FACPAC Contract Change Order Supplemental Information Form (Ref# 64588)

Tier 1 Project: Phase 6 Additions and Renovations - Project #175-520
BG Number: 21-042 District: Beechwood Independent (HB678) (026)
Status: Active Phase: Project Initiation (View Checklist)

CHANGE ORDER NUMBER: 302-01
INITIATION DATE: 3/17/2026

CC1 Softball Field grade beam and slab
 PR2 Add masonry scope to project

2 DUGOUT FOUNDATION PLAN
 SCALE: 1" = 5'

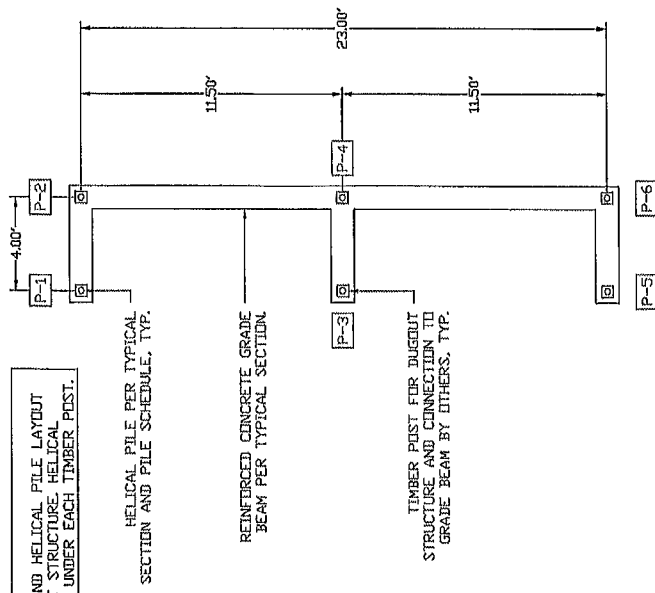
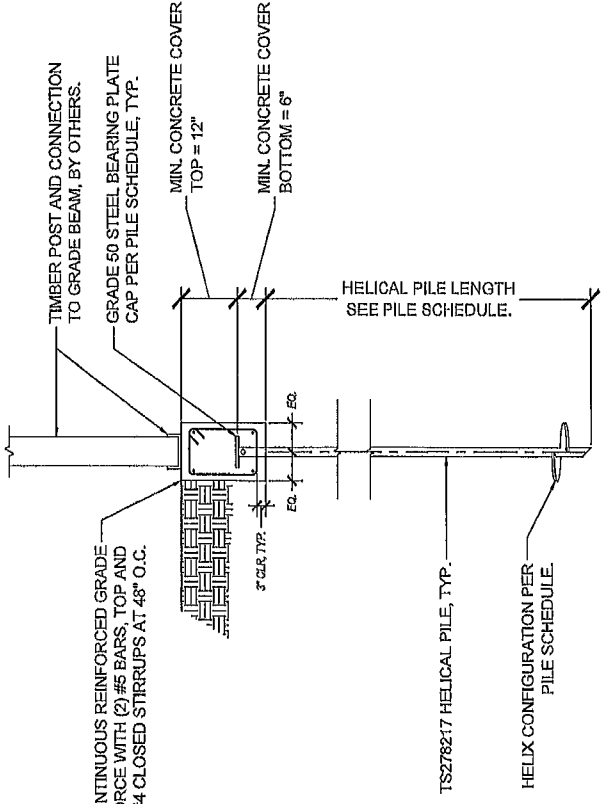
CC1 Softball Field grade beam and slab

Reference: Beechwood Phase 6C Softball Field Dugout Grade Beam and Slab

We purpose to furnish and install all labor and material for new grade and concrete slab and install existing dugout.

Concrete contractor did not include the whole pad in original proposal.

38 LF- 12"x18" grade beam
120 SF- Dugout slab, 5" concrete, 42# mesh, 4" #304 gravel

NOTES:
 1. CONFIRM DIMENSIONS AND HELICAL PILE LAYOUT WITH EXISTING DUGOUT STRUCTURE. HELICAL PILES TO BE LOCATED UNDER EACH TIMBER POST.

HELICAL PILE PER TYPICAL SECTION AND PILE SCHEDULE, TYP.
 REINFORCED CONCRETE GRADE BEAM PER TYPICAL SECTION.
 TIMBER POST FOR DUGOUT STRUCTURE AND CONNECTION TO GRADE BEAM BY OTHERS, TYP.
